**Comments on
Addendum Subsequent Environmental Impact Report
CERRS Waste Management Facility
developed by County of Colusa Department of Planning and Building
January 1997**

Submitted by
G. Fred Lee PhD, DEE
G. Fred Lee & Associates

February 3, 1997

Map of proposed CERRS landfill area

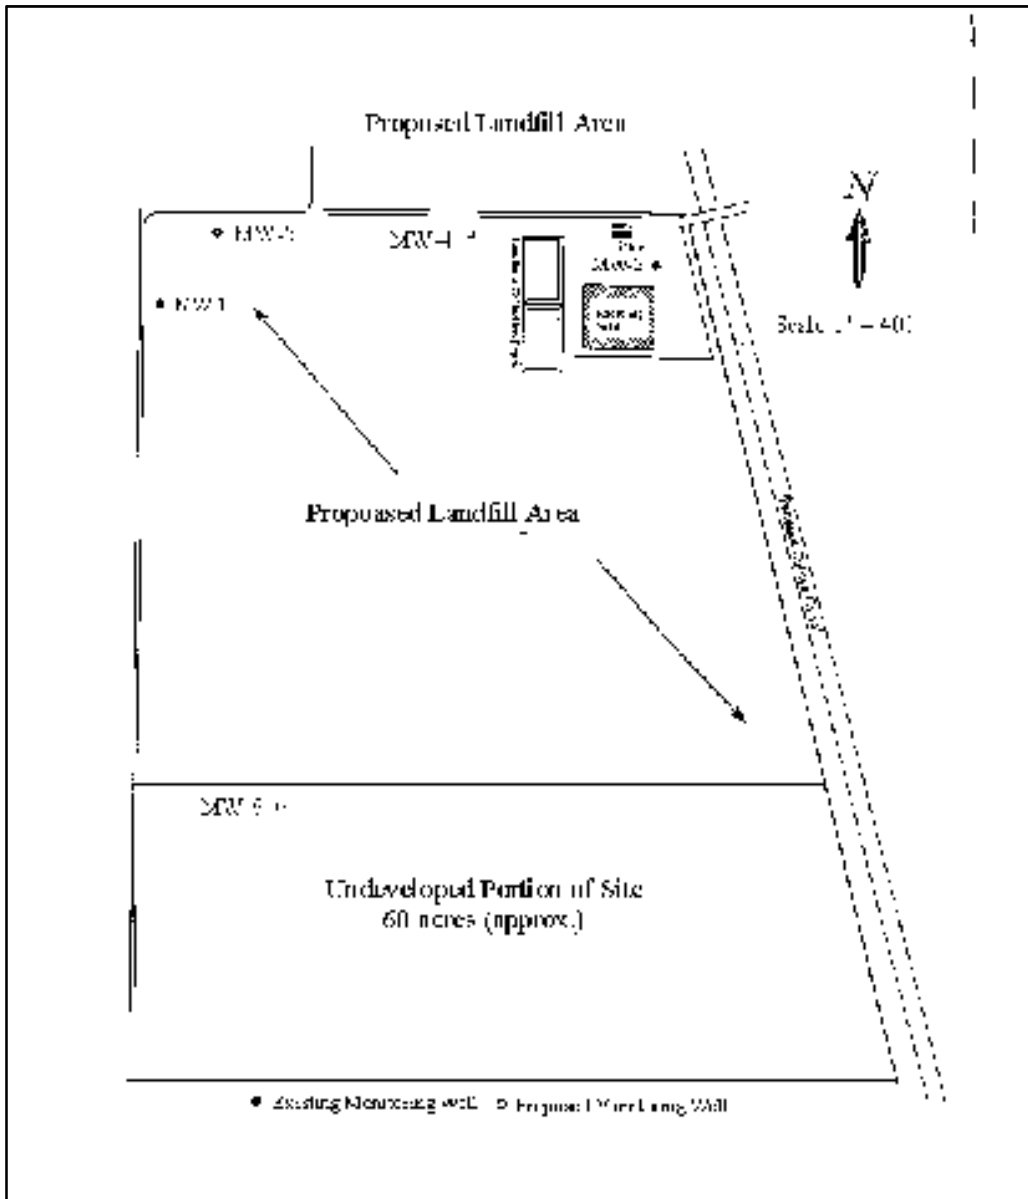
Reliability of the Leak Detection System

The ASEIR states on page 2,

"The integrity of the liner system will be monitored through the use of lysimeters that will be placed at strategic points in the soil below the facility liner (DSEIR page 4-18). Sample tubes

will extend from the lysimeters up to the surface to allow water samples to be extracted from the lysimeters and tested for the presence of leachate."

It also states,

"A series of new groundwater monitoring wells, in addition to the wells already in place, will also be installed in accordance with the direction of the Regional Water Quality Control Board, to monitor the quality of the groundwater up-gradient and down-gradient of the facility (DSEIR page 4-17)"

*Pattern of Landfill Leakage - Groundwater Contamination from Lined Landfills
(After Cherry, 1990)*

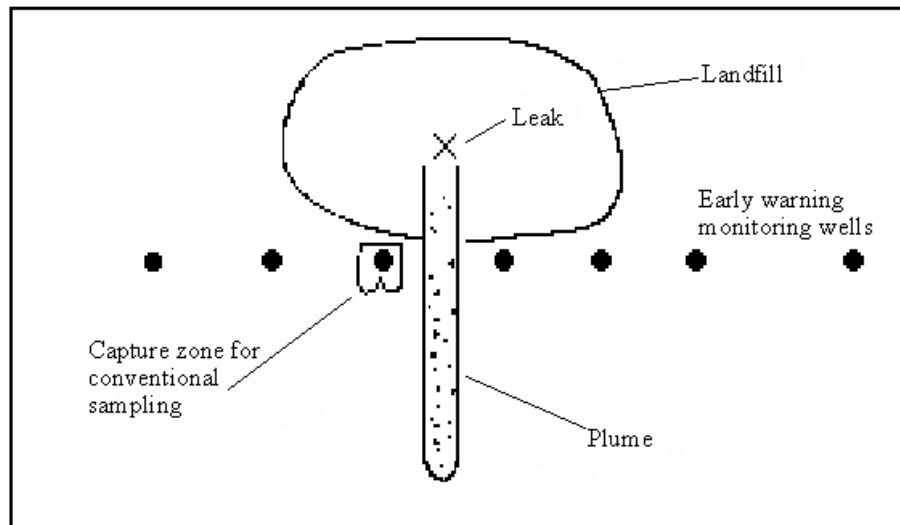
The fundamental problems with the groundwater monitoring that is proposed for use at the CERRS landfill facility is that the initial leakage through the liner system will occur through holes, rips, tears, or points of deterioration in the liner. As Cherry (1990) pointed out, such points of leakage will produce finger-like plumes of leachate. The CERRS facility is proposed to have monitoring wells spaced hundreds of feet apart. Each monitoring well has the ability to detect leachate about 1 foot on each side. Therefore, unless the monitoring wells are spaced about 10 feet apart, significant leakage of leachate through the liner system into the underlying groundwaters can occur and not be detected by the monitoring wells. This situation is shown diagrammatically in the attachments to these comments.
